Mesa 500-kV Substation Project CPUC Minor Project Change Form

Report No.: 07

RE: Mesa 500-kV Substation Project – Minor Project Change No. 7 Request: Additional Splice Work for Telecom Conduit Changes

MESA 500KV SUBSTATION
MINOR PROJECT CHANGE SEVEN
SPLICE 1 V5127267 (CABLE 01088)

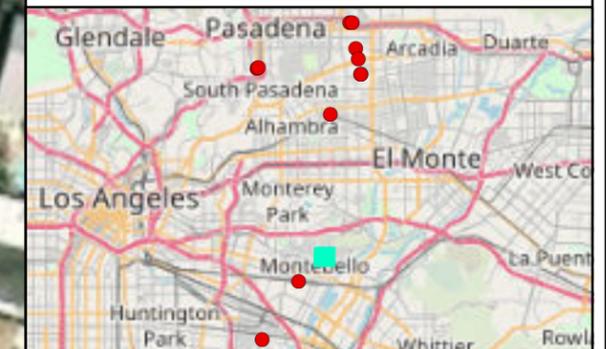
- Justification for change: Due to communications load, additional communications fibers are required at 4628561E, V5127267, M5422379, 1825243E, M5008337, X9301368, V5008363, 4415620E, 4415631E, 4171874E, 2013401E, and 1547107E.

- In the City of Montebello: For vault V5127267, traffic control will be provided for a 1-lane closure and pedestrian access will not be affected since the vault is located on the roadway. For manhole M5422379, which is located on the sidewalk, pedestrian and traffic control will be provided as necessary.

MESA 500KV SUBSTATION
MINOR PROJECT CHANGE SEVEN
SPLICE 12 M5422379 (CABLE 04142)

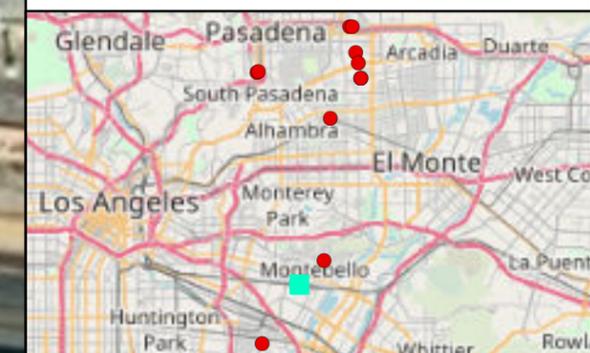
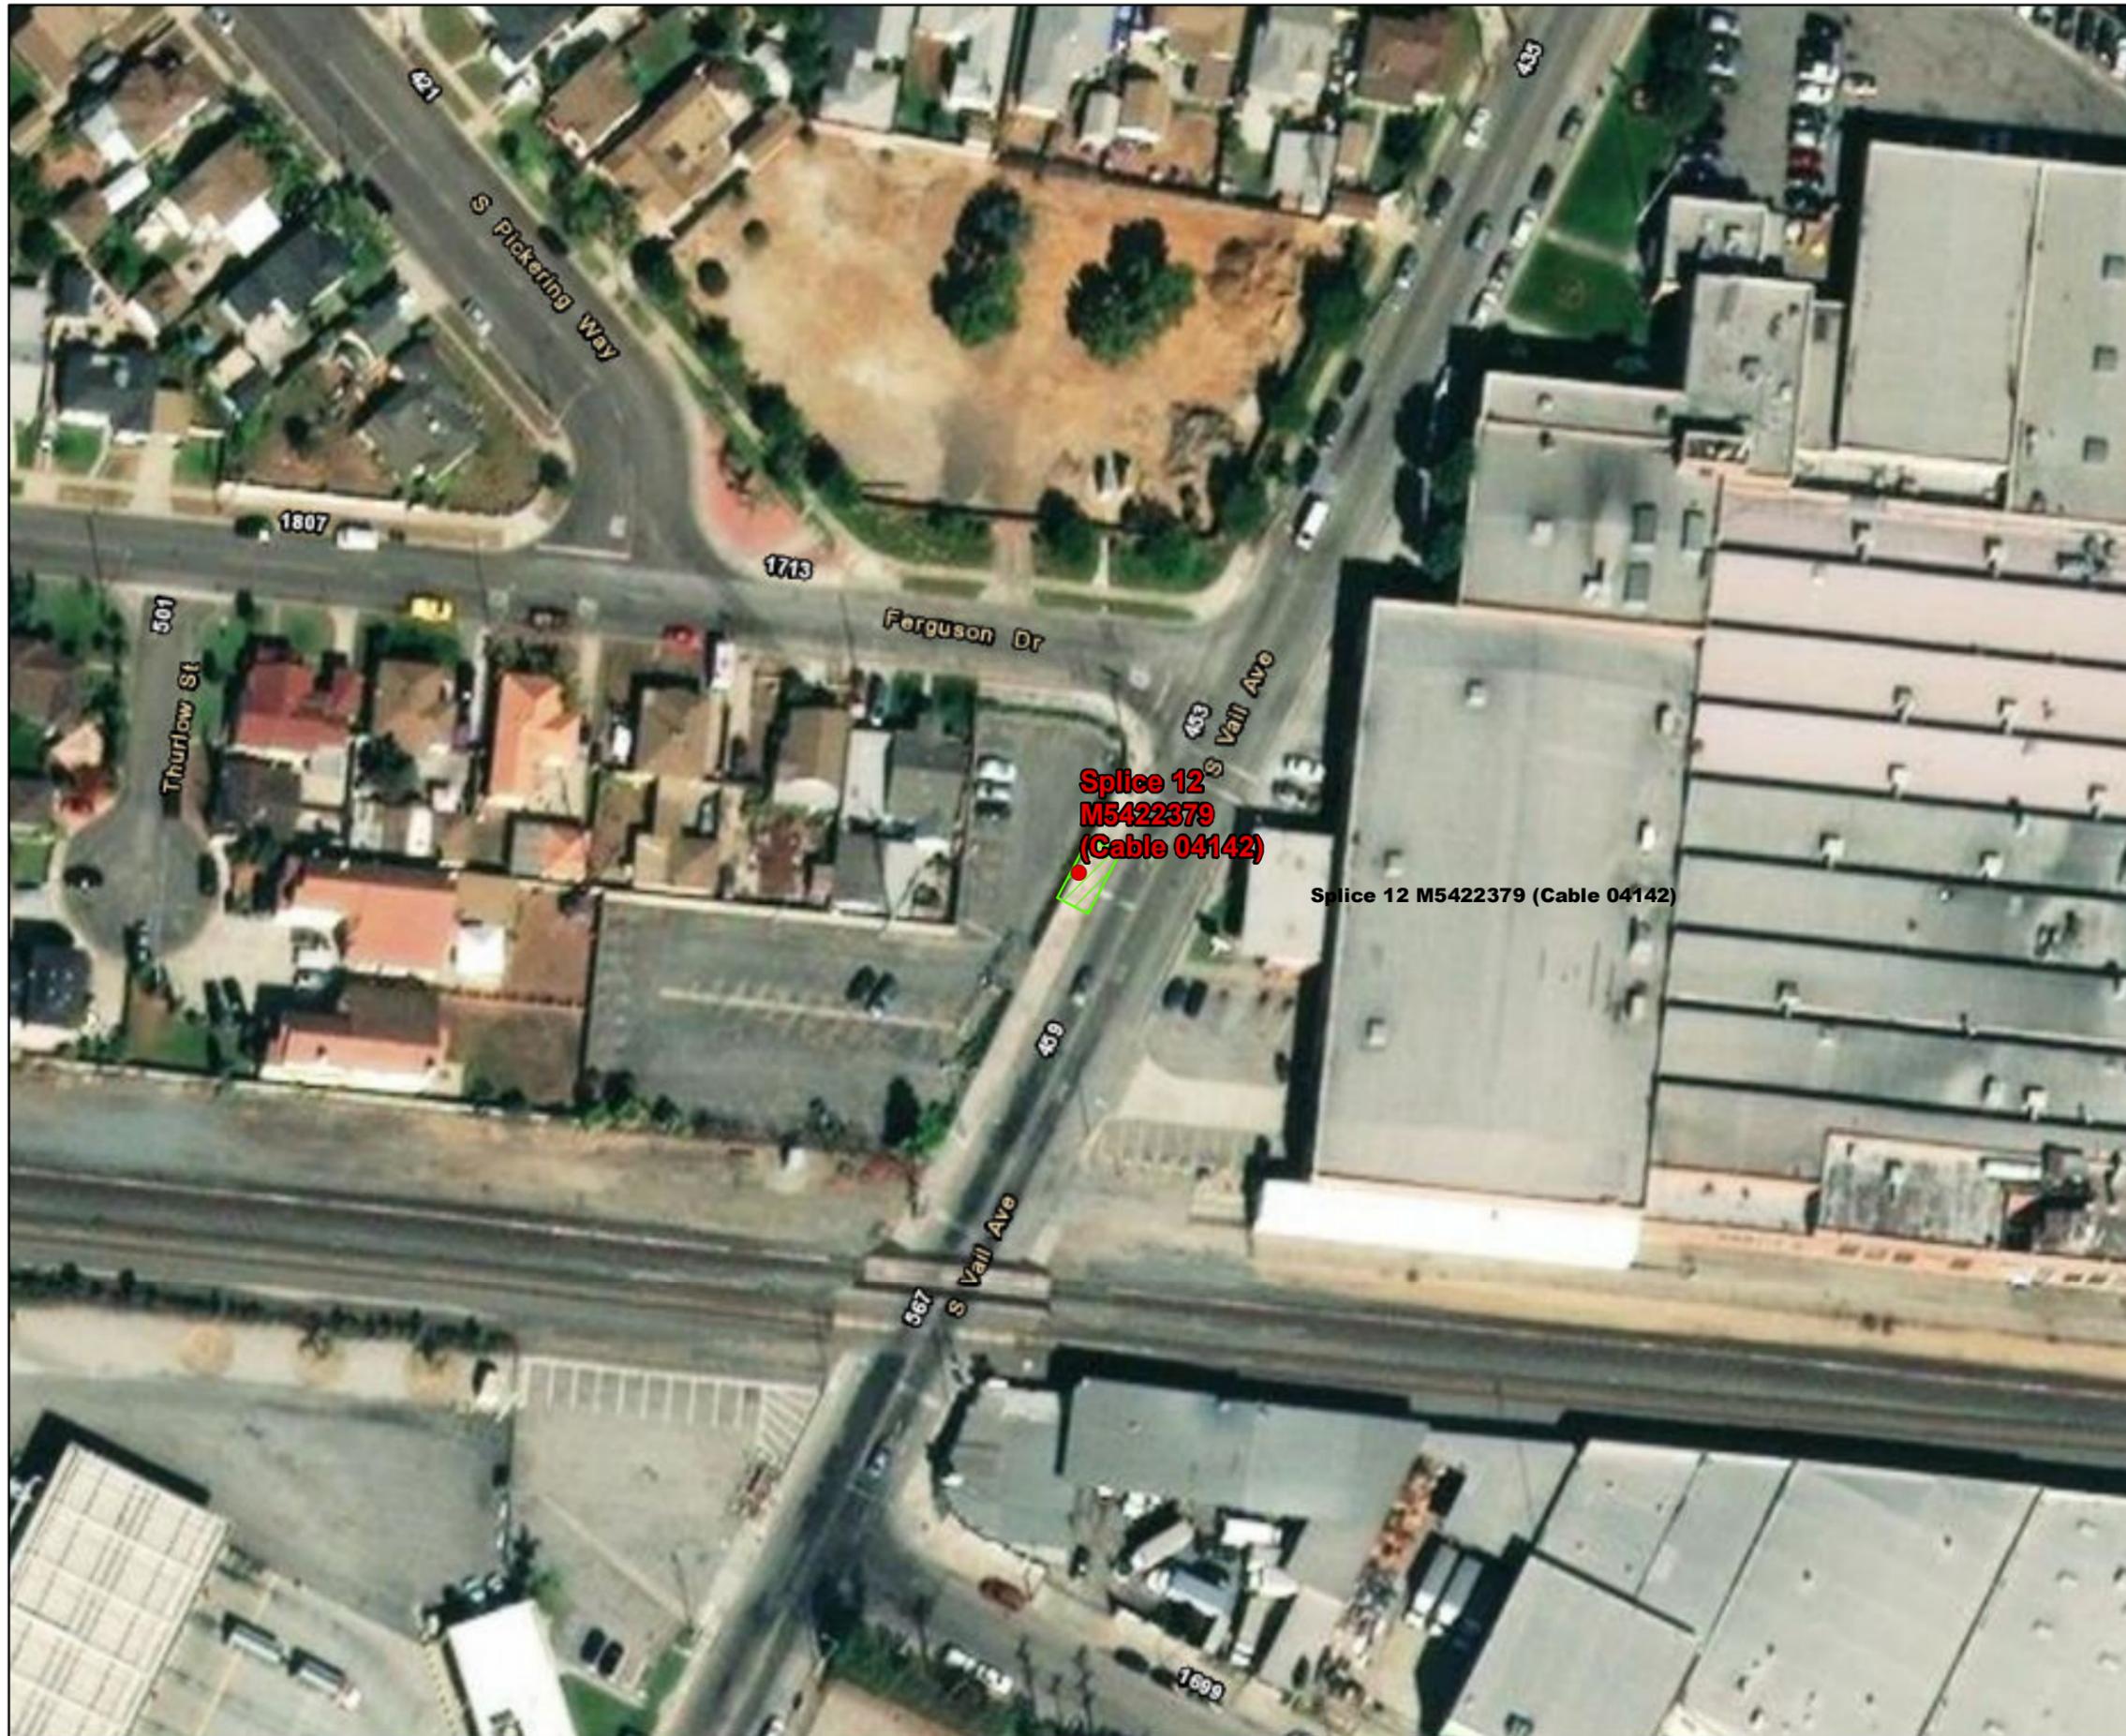
Manhole M5422379 is located on the sidewalk. During construction, SCE will ensure that one of these sidewalks will be available for public use. Any temporarily unavailable sidewalk will be marked, and pedestrian traffic control will be present to ensure the safety of non-project individuals when construction crews are at or near the sidewalks.

MESA 500KV SUBSTATION
MINOR PROJECT CHANGE SEVEN
SPLICE 2 M5008337 (CABLE 01094)

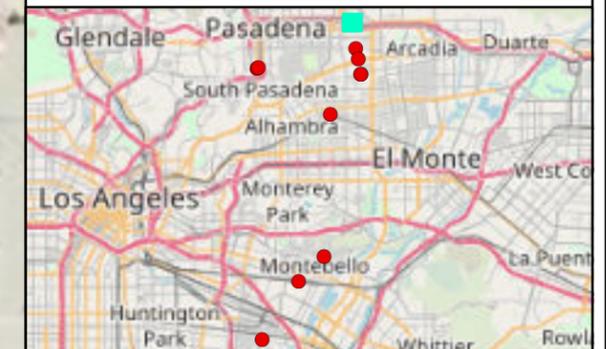
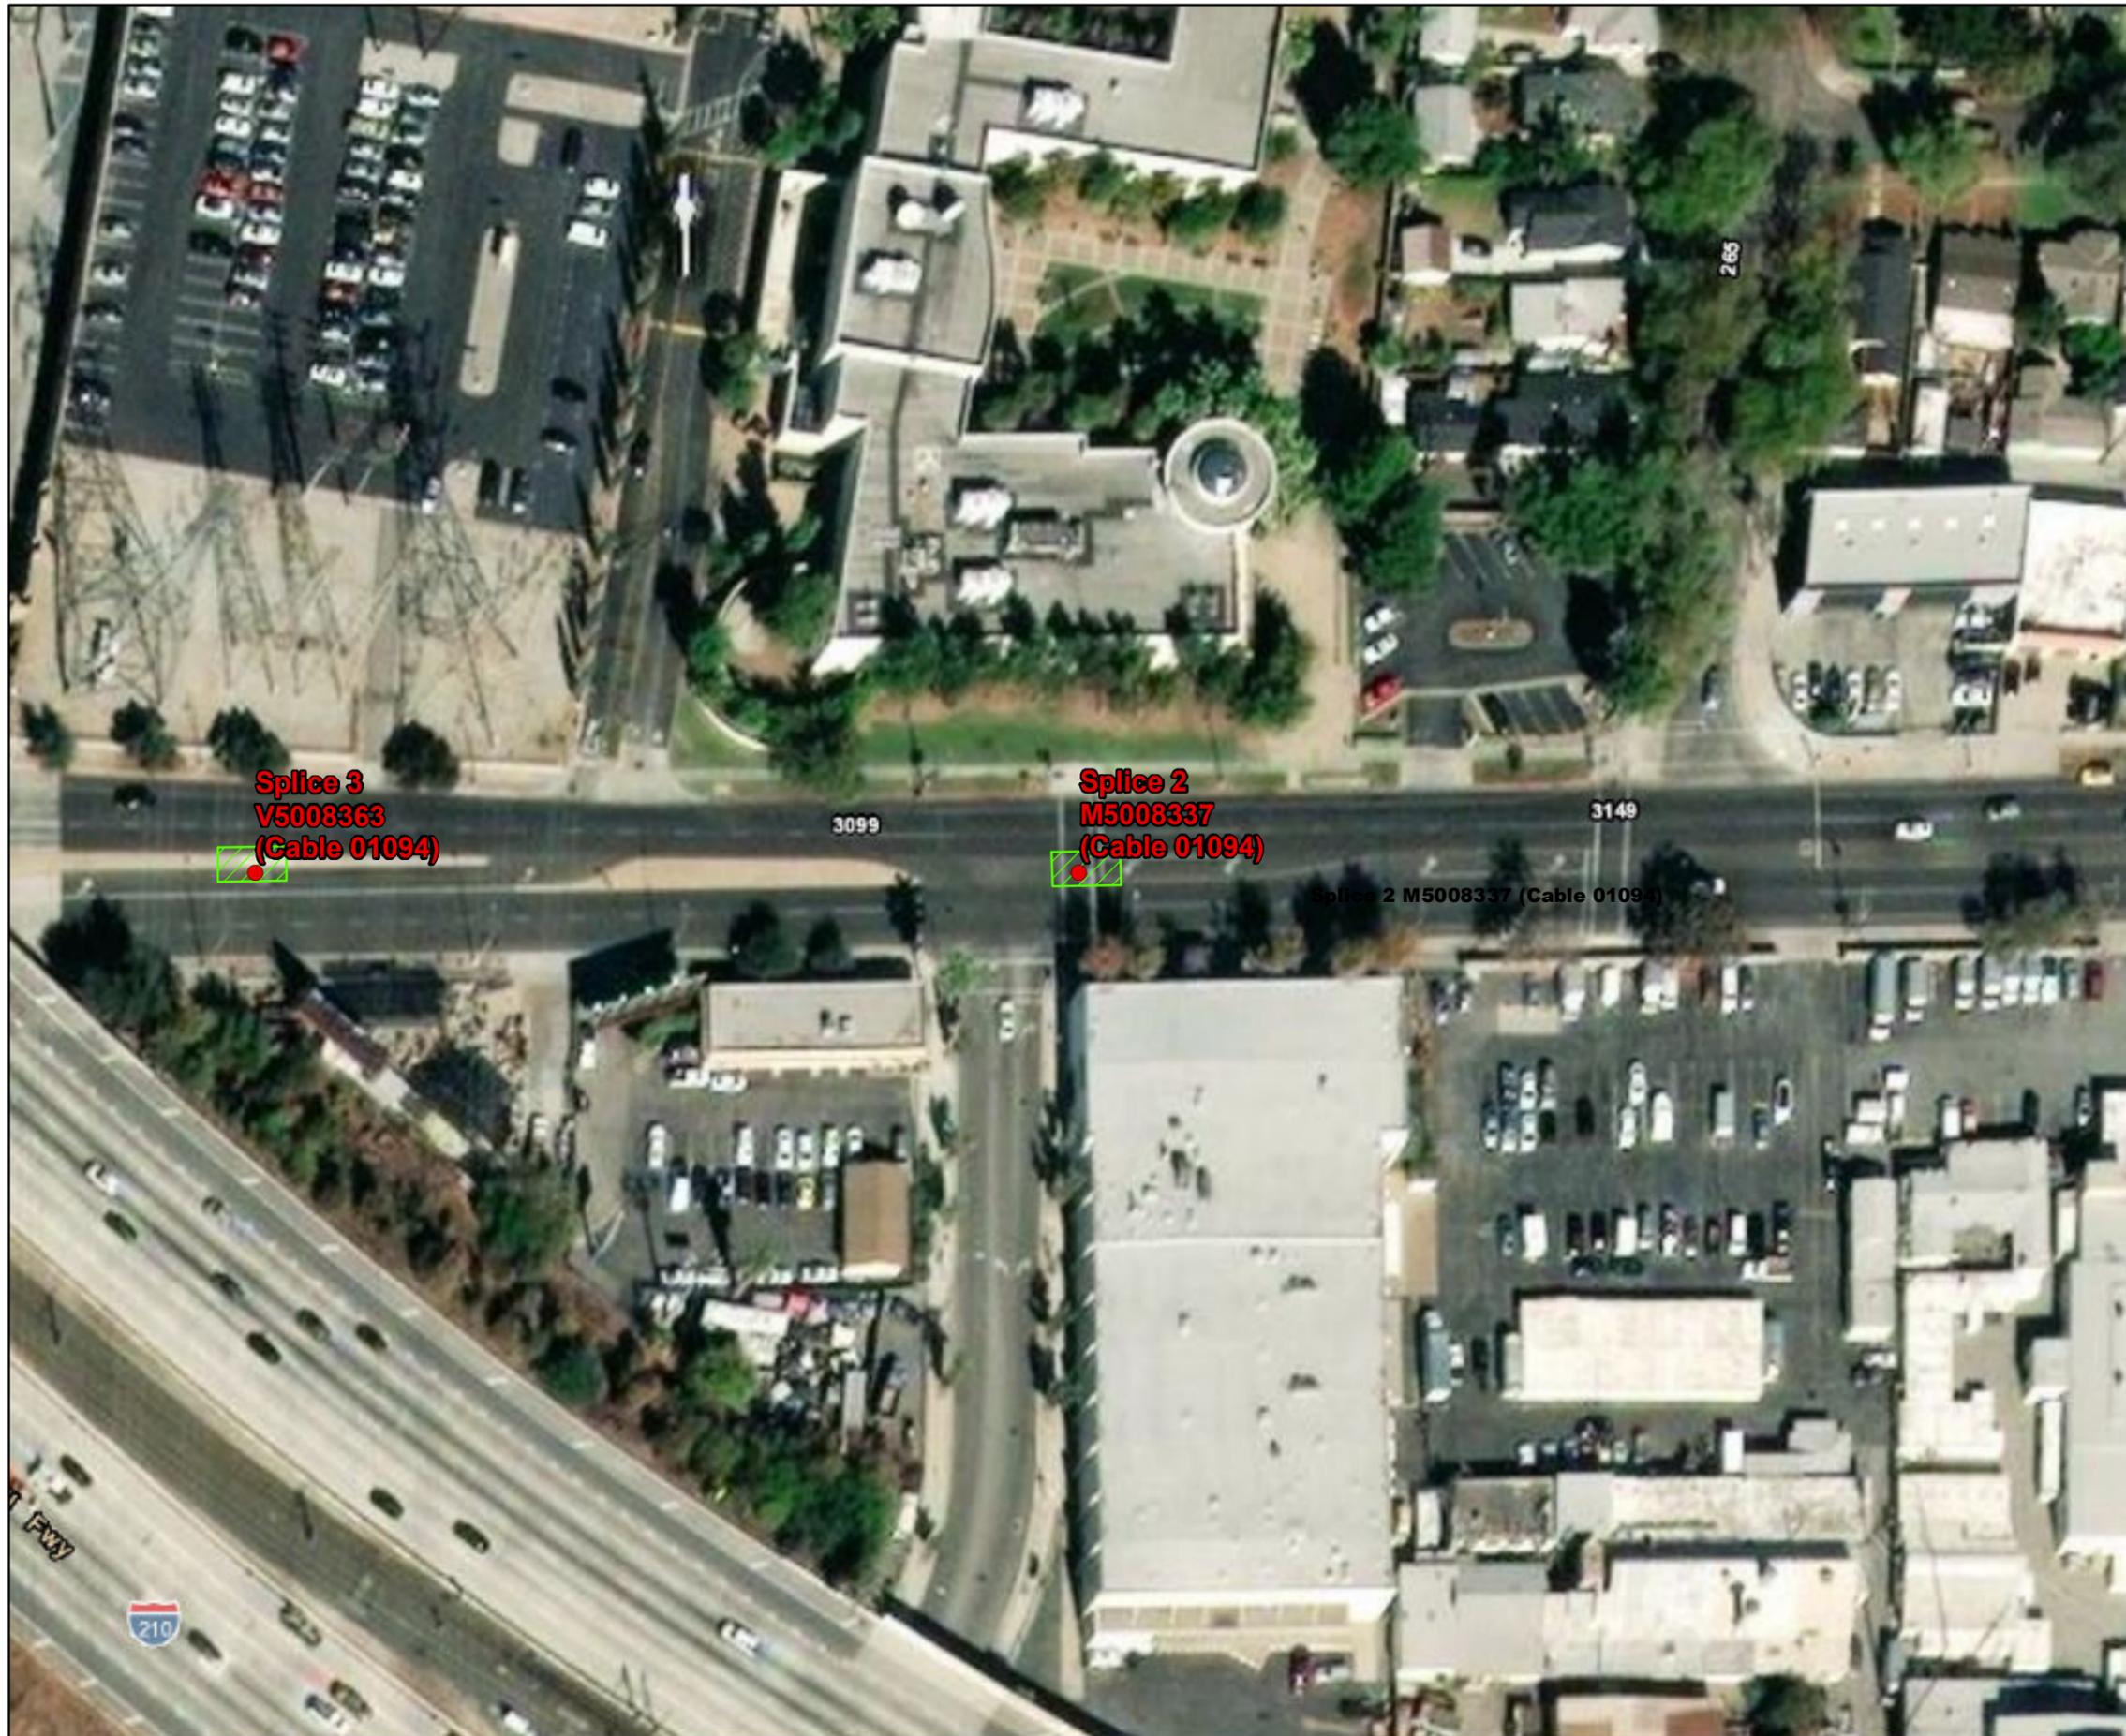
- In the City of Pasadena: For manhole M5008337 and vault V5008363, which are located near the center divider of E. Foothill Boulevard and Santa Paula Avenue, appropriate traffic control will be provided. For poles 4415620E, 4415631E, 4628561E, and 1825243E, traffic control is not required because these poles are located in the SCE right-of-way on SCE property.
- In the City of San Gabriel: For poles 4171874E and 2013401E, traffic control is not required because these poles are located in the SCE right-of-way. For pole 1547107E, traffic control will be provided for a 1-lane closure, with assistance for pedestrian access as needed.
- In the City of Bell Gardens: For manhole X9301368, traffic control is not required because this pole is located on SCE Property away from the street.
